Charlotte-Mecklenburg Planning Department

SUBJECT: Administrative Approval for Petition No. 1989-096 The Flad Mullinax Partnership

PROJECT NAME: U.S. FOODS - EASTWAY EXPANSION

U.S. FOODS

ELEVATIONS

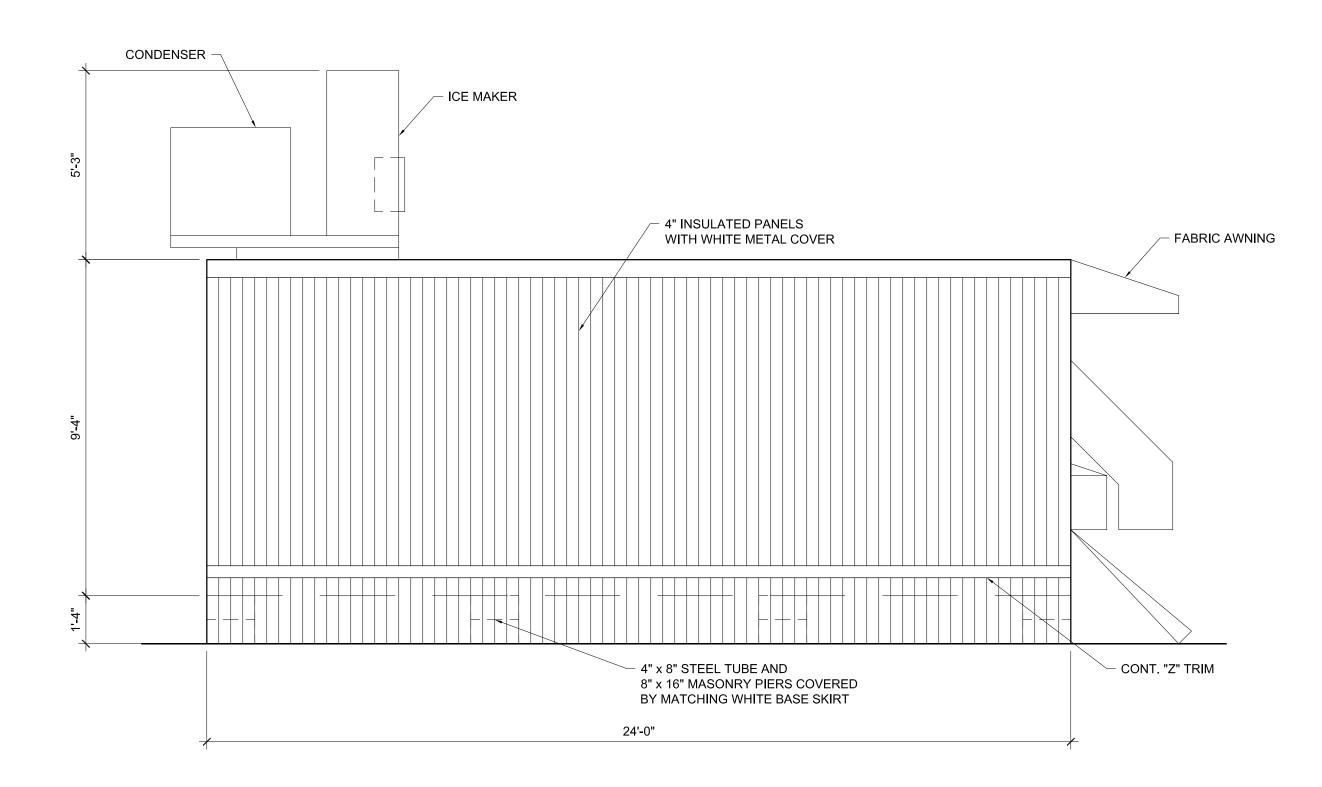
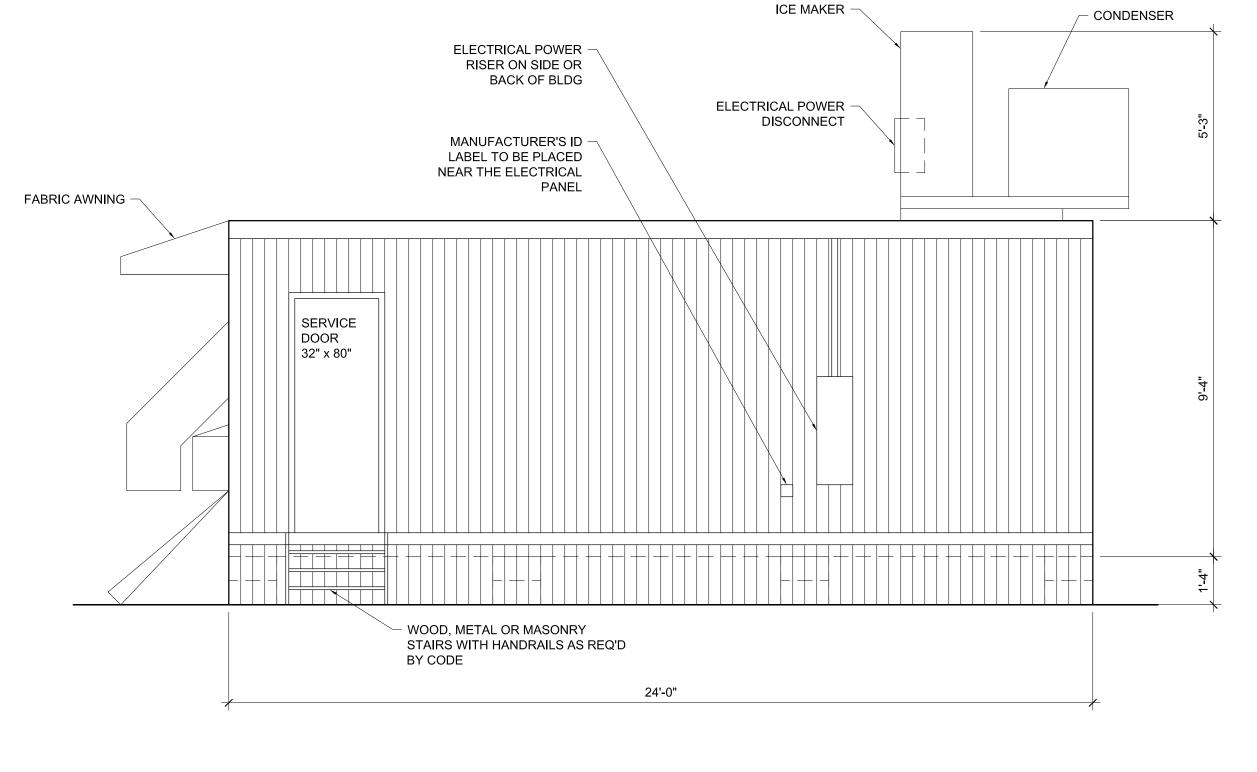
- Elevations for an accessory retail use (Ice House).
- Site layout plan and landscaping.
